CASE # 2011-102194R  
TCAD # 0413110944

APPLICATION TO THE RESIDENTIAL DESIGN  
AND COMPATIBILITY COMMISSION (RDCC)

GENERAL MODIFICATION WAIVER

STREET ADDRESS: 1316 Central Park Ct

1316 CENTRAL PARK CT

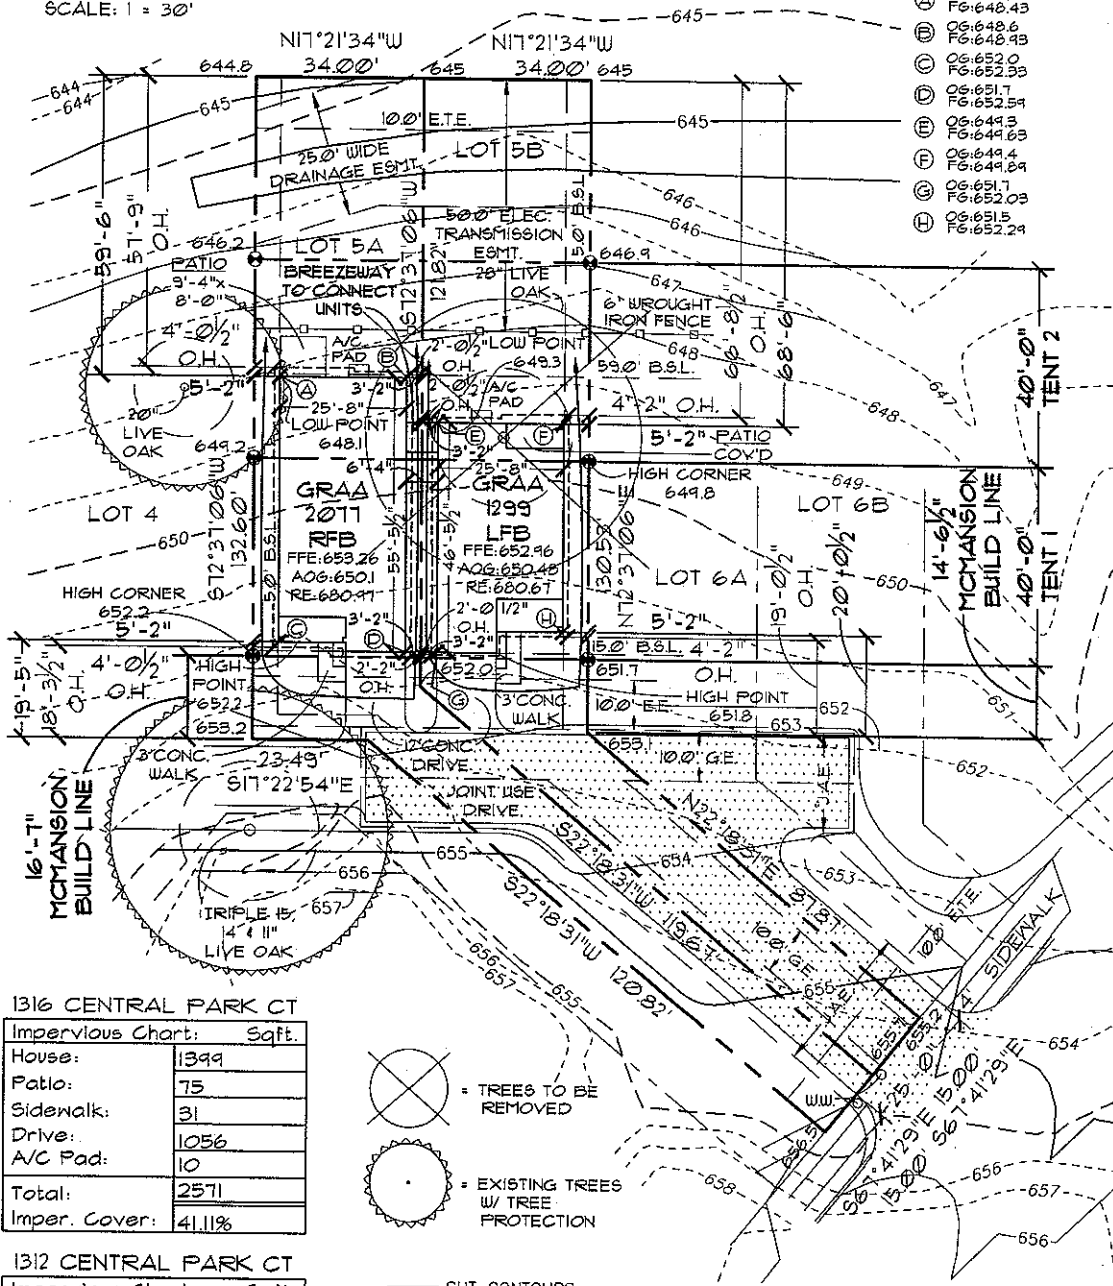
1316 Lot 5A - Variance from the Board of Adjustment for encroachment into the 25' Front Setback area.  
Approval from RDCC,

1316 Lot 5A - Variance from the Board of Adjustment for encroachment into the 25' Front Setback area.  
 Approval from RDCC,  
 Tree Review Required by City Arborist. Developer to set up appointment with City Arborist, supply arborist with a current site plan.
